To: All U.S. and Canadian Volvo Retailers
Subject: Service Campaign S29650

**Service Campaign S29650: Engine Oil Specification Upgrade
Model Year 2012 S60 Engine Code 62**

TITLE:
Service Campaign S29650: Engine Oil Specification Upgrade

QB Instruction VCC-489268-1

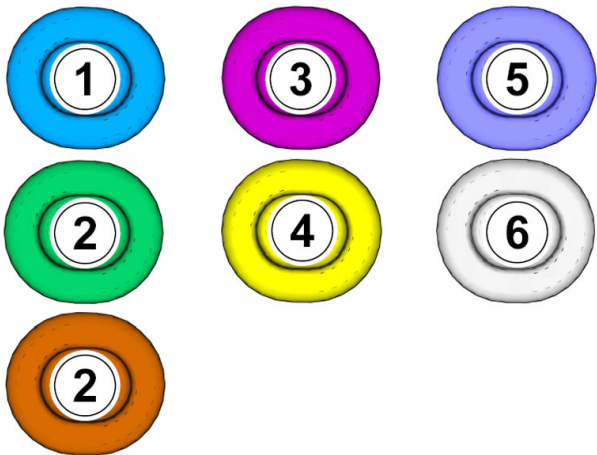
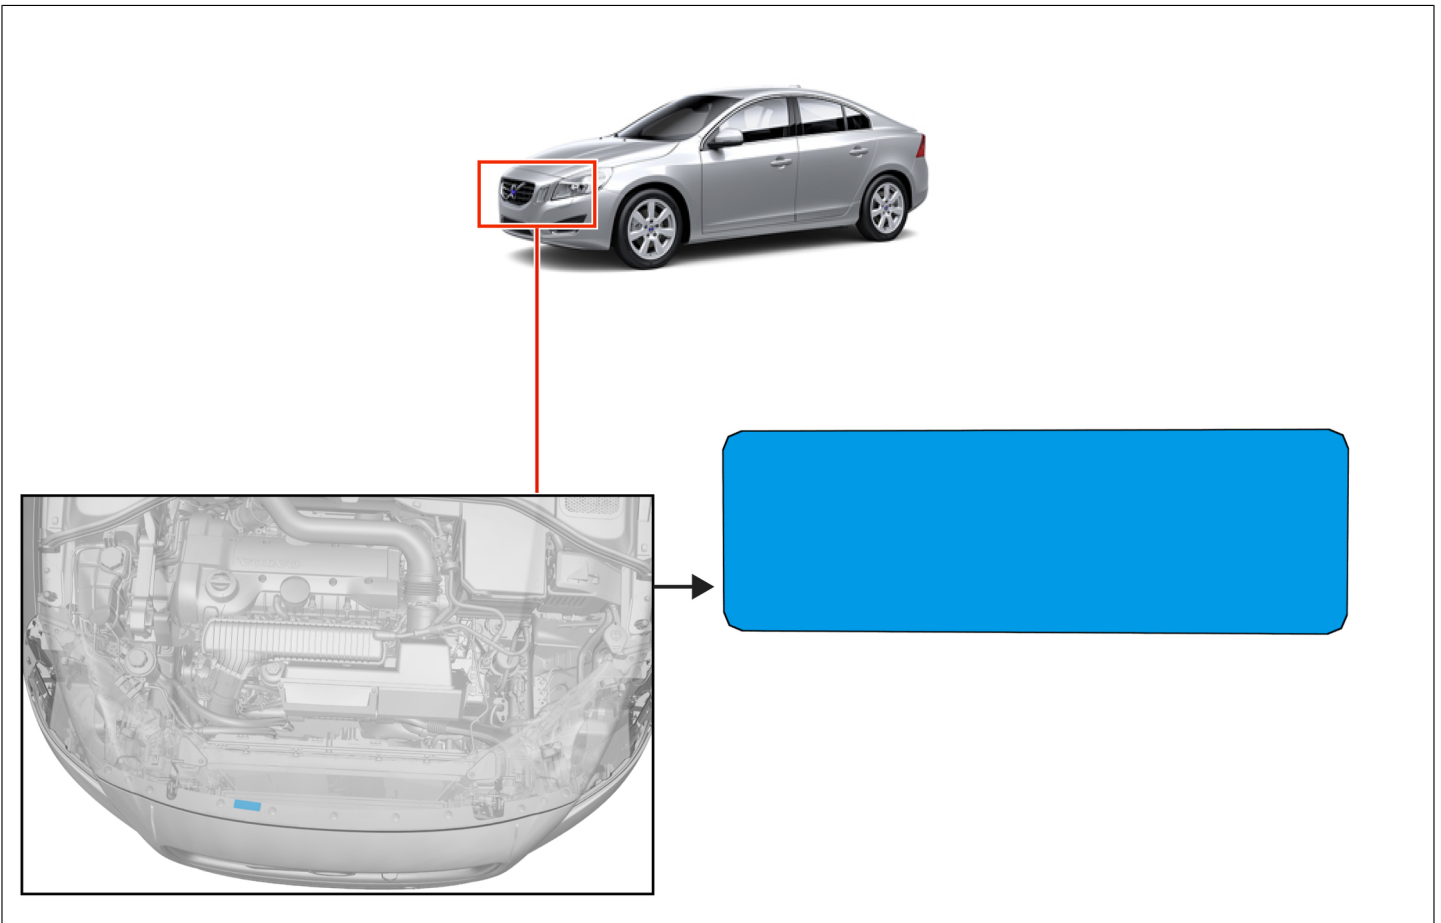
Caution! Make sure that the surface is clean and free of foreign material.

Fit the decal.

Use: Isopropanol , 31375638

Viscosity chart

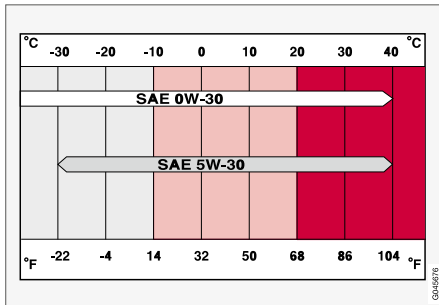
Full synthetic engine oil meeting the minimum ACEA A5/B5 must be used. Lower quality oils may not offer the same fuel economy, engine performance, or engine protection.

Incorrect viscosity oil can shorten engine life under normal use. SAE 5W-30 will provide

good fuel economy and engine protection.
See the viscosity chart.

SAE 0W-30 oil meeting ACEA A5/B5 requirements is recommended for extreme driving conditions.

Viscosity chart

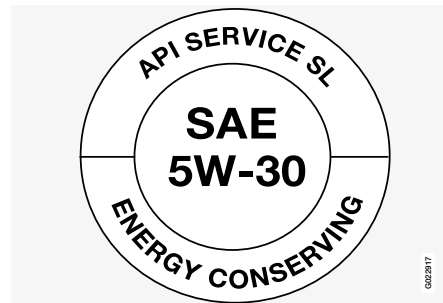
Only full synthetic oil meeting ACEA A5/B5 requirements should be used. Lower quality oils may not offer the same engine performance or engine protection.

Incorrect viscosity oil can shorten engine life under normal use. SAE 5W-30 will provide good fuel economy and engine protection. See the viscosity chart.

Synthetic oils meeting SAE 0W-30 or 0W-40 and complying with oil quality requirements are recommended for driving in areas of sustained temperature extremes (hot or cold), when towing a trailer over long distances, and for prolonged driving in mountainous areas.
